AGENDA – WORKSHOP OF THE PLANNING & ZONING COMMISSION OF THE CITY OF PEARLAND, TEXAS, TO BE HELD ON APRIL 21, 2008, AT 6:00 P.M., IN THE COUNCIL CHAMBERS, CITY HALL, 3519 LIBERTY DRIVE, PEARLAND, TEXAS.

A. COMMISSION INPUT AND DISCUSSION: REGARDING PROPOSED MULTI FAMILY (55+) PLANNED DEVELOPMENT (TOWNEPLACE RESERVE) LOCATED GENERALLY ON THE WEST SIDE OF CULLEN BOULEVARD AND SOUTH OF BROADWAY.

**AGENDA REQUEST
BUSINESS OF THE CITY COUNCIL
CITY OF PEARLAND, TEXAS**

A. COMMISSION INPUT AND DISCUSSION: REGARDING PROPOSED AMENDMENTS TO THE PEARLAND TOWN CENTER PD, GENERALLY LOCATED AT THE INTERSECTION OF BROADWAY AND SH 288, REGARDING SIGNAGE, TRANSPARENCY, AND MULTI-FAMILY PARKING RATIO.

TOWNE PLACE RESERVE
 AFFORDABLE SENIOR HOUSING P.U.D. PEARLAND, TEXAS

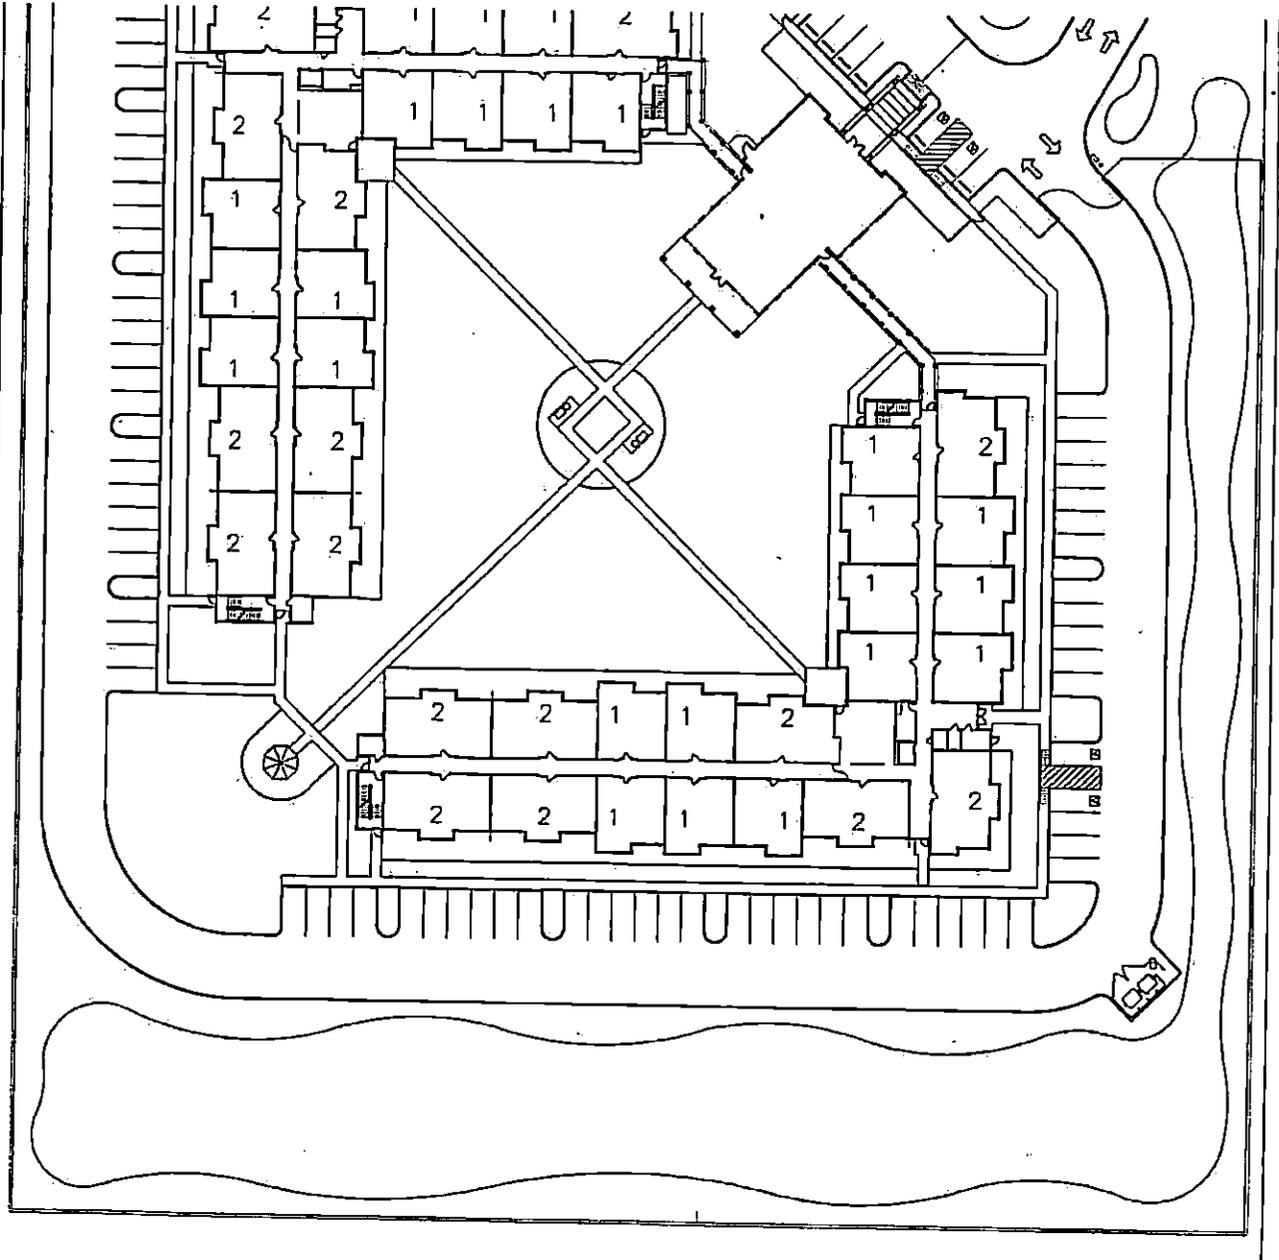
The PD is not clear and it seems like 120 units are proposed. The units are a combination of one and two bedrooms. Staff has reviewed the PD and has the following preliminary comments:

4. **Density:**
SR-12 allows a density of 2.3 units per acre. A Multi-family zone allows a density of 16 units per acre. It appears that the proposed development, with 120 units on 6 acres, is at a higher density of 20 units per acre. The PD needs to provide this information.

5. **Open Space and Amenities:**
Multi Family zone requires 900 sq. ft. of common open space per unit. This development would require 2.4 acres of common open space, excluding detention. The PD does not specify how much is provided. The land use tables are incomplete. Staff recommends that the PD met all the common open space requirements of MF zone.
It is not clear what kind of amenities will be provided. The design plan does not indicate if a swimming pool or similar facilities will be located within the community building.

7. **Parking:**
The PD proposes a ratio of 0.75 spaces per unit. UDC requires 2 spaces for 1-bedroom unit and 2.5 for 2-bedroom unit. There is no separate ratio for 55+ housing. Other such developments in the past were directed by the Council and P & Z to provide the ratio required in the UDC, since it was a general feeling that 55+ residents would still be driving their own automobiles. Further, community building would need additional parking at a rate of 1 space per 100 sq. ft. of floor area used for assembly.

8. **Landscaping Requirements:**
There is no landscaping plan attached as required. The PD has some general requirements, which may or may not meet the UDC requirements. Staff recommends that all requirements of the UDC be met.

The proposed development abuts an approved residential PD and thus would require buffering and fencing. These details have not been shown or addressed.

10. Platting: It is not clear if the parcel as shown can be platted. Need more details on the proposed cul-de-sac, lot width etc. Shows a road, which is not constructed yet. The proposed cul-de-sac would need sidewalks on both sides.

13. PD does not list any deviations from the UDC, and the plan is not specific. Therefore, it is not clear what deviations are requested.
14. Staff recommends that a complete PD document be provided, addressing all the points in the template, for further review.

Exhibit B Interior Project Boundary

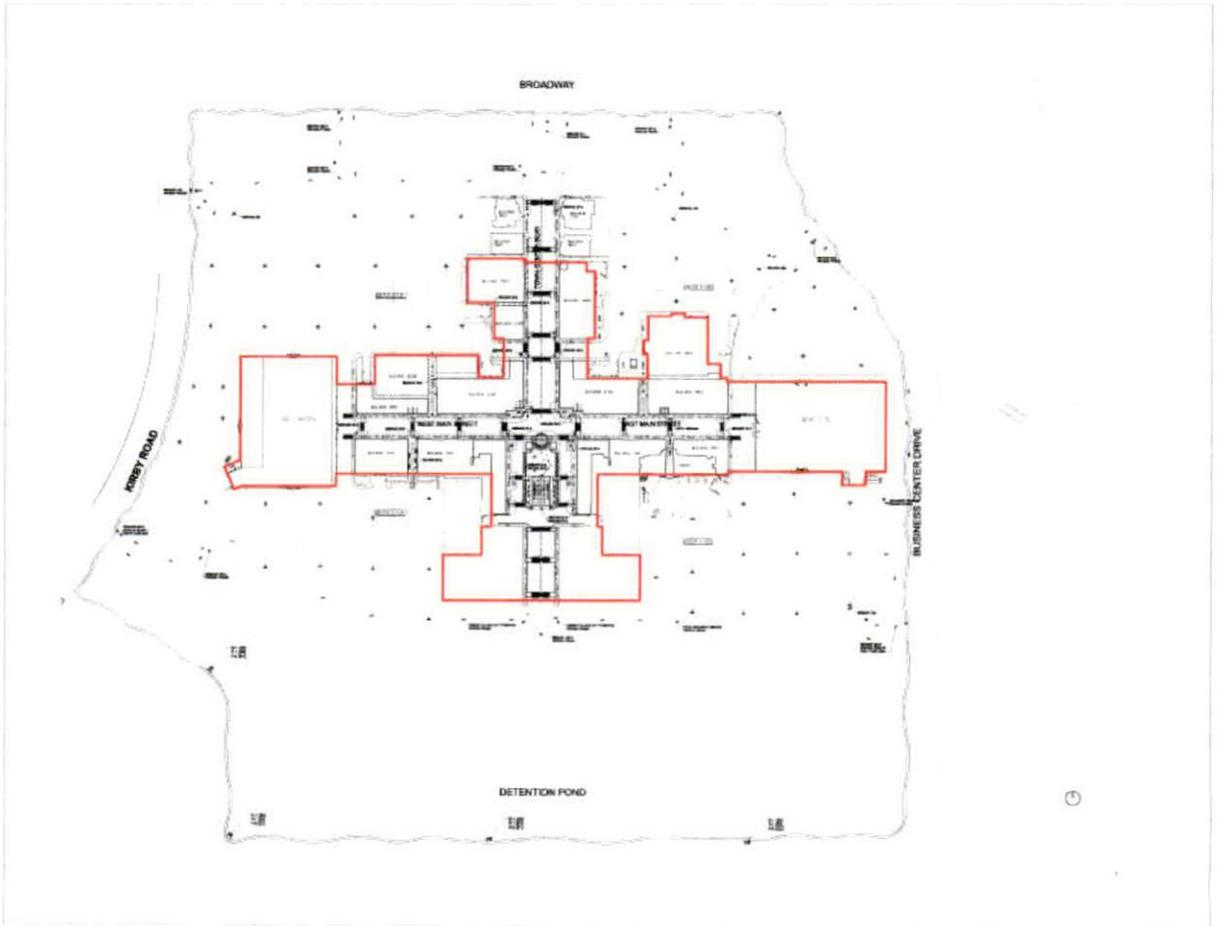
These signs would be located within the interior project boundary and the applicant is requesting that these be exempt as long as the height of the sign does not exceed the height of the building. (Pages 36 and 38). This would be similar to signage inside an enclosed shopping mall.

Exhibit C On-Premise Wayfinding Signs

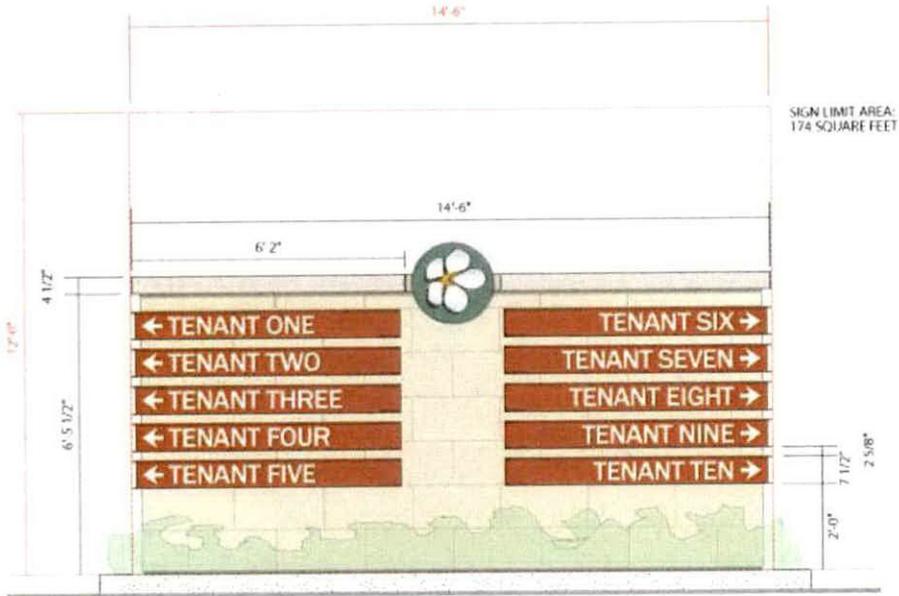
The applicant is proposing to add another type of signage – On-premise Wayfinding Signs. These are signs that would direct visitors to various stores and are proposed to have a maximum area of 174 sq. ft. and height of 12'. (Pages 32, 36, and 39).

Staff recommends that the PD clarify that the maximum area includes the base.
